Support Document for the Revised National Priorities List Final Rule – Orange County North Basin

This document provides responses to public comments received on the Orange County North Basin site, proposed on January 18, 2018 (83 FR 2576). This site is being added to the NPL based on an evaluation under EPA's Hazard Ranking System (HRS) in a final rule published in the *Federal Register* in September 2020.

Figure 1: Wells within 2 Miles of the Groundwater Plume.

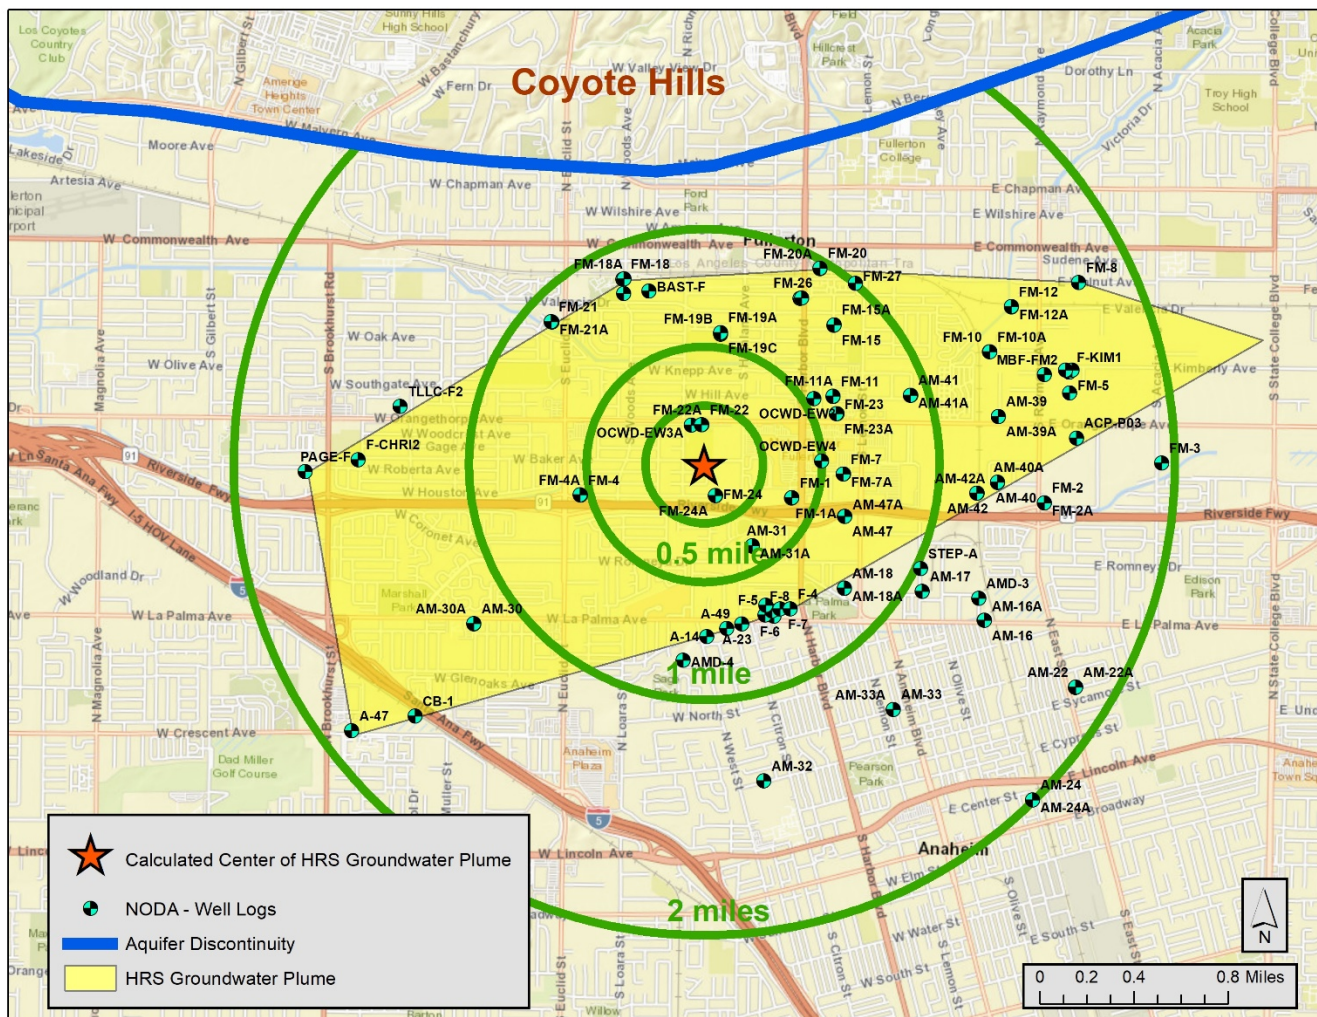
As referred in the above quote, Section 3.1.1 Observed Release of the HRS documentation record at proposal, specifically page 38, contains a table of deep monitoring wells at the Site that meet observed release criteria, summarized in Table 1 of this support document below. As shown on Figure 1 below wells FM-10, FM-11, FM-12, FM-19B, FM-22, FM-23, and FM-24 are all located within 2 miles of the center of the groundwater plume.

The HRS documentation record at proposal sufficiently documents that the shallow and principal aquifers⁶ at the Site are interconnected for HRS purposes by demonstrating that Site-related contamination has migrated into the principal aquifer from the shallow aquifer.

In conjunction with this regional information, the EPA provided evaluation of the aquifers in the vicinity of the Site. To demonstrate that the shallow and principal aquifers are interconnected within 2 miles of the Site, the EPA developed a TDL and evaluated aquifer conditions and wells within 2 miles of the center of the groundwater plume for the presence of continuous confining layers and/or evidence of contaminant migration (see Figure 2 of

the HRS documentation record at proposal and Figure 1 of this support document). As described above, the EPA utilized regional studies⁷ with information specific to the North Basin in Orange County, California to determine that the subsurface below the Site consists of interconnected sand and gravel deposits with discontinuous lower-permeability clay lenses that do not hydraulically isolate water-bearing zones. Additionally, one of these studies (HRS documentation record Reference 22) found VOC contamination in wells as deep as 600 feet bgs in the vicinity of the Site.
